OUTDOOR

POWER EQUIPMENT

PRODUCT SERVICE BULLETIN

Mower Motor Modification

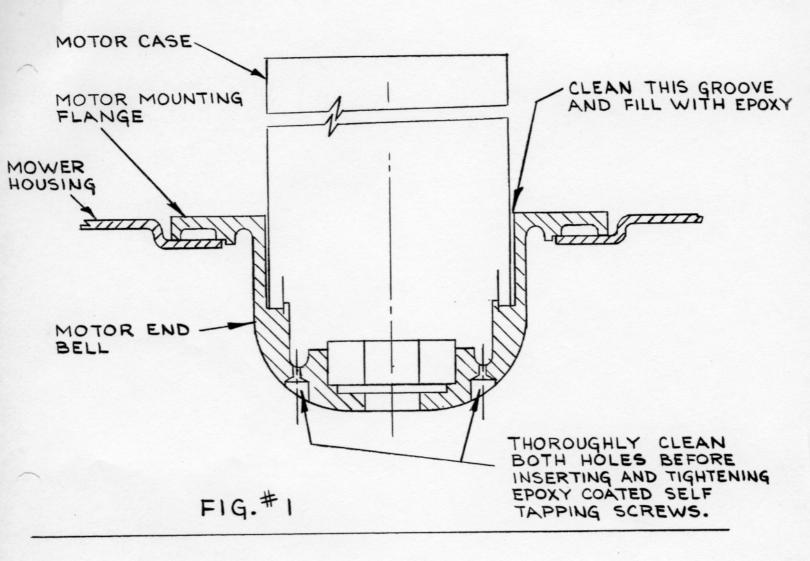
- 1. If the mower has not just be unpacked, wipe all motor surfaces clean above and below the mower deck.
- 2. Thoroughly clean and dry the groove between the outside of the motor case and motor mounting flange of each motor. In the absence of compressed air, clean the groove with shim stock or the equivalent. If there is evidence of moisture in the groove, dry unit before proceeding. See Figure 1.
- 3. Expose underside of mower and clean the two drain holes in each motor end bell. See Figure 1.

F19. # 2

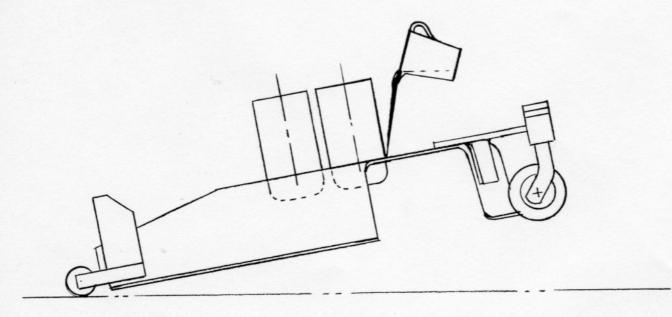
Pouring is made easier if the front edge of the mower deck is tilted up and half of the groove on that side is filled. Tilt the opposite side to fill the other groove half. See Figure 2.

- 2. Stir the mixture for two minutes.
- 3. Dip the threads of six self-tapping screws into the mixture before fully screwing them into the holes in each motor's end bell (underside of deck).
- 4. Pour the bonding mixture into the previously cleaned groove of each motor on either side of the existing bonds until the grooves are completely filled.
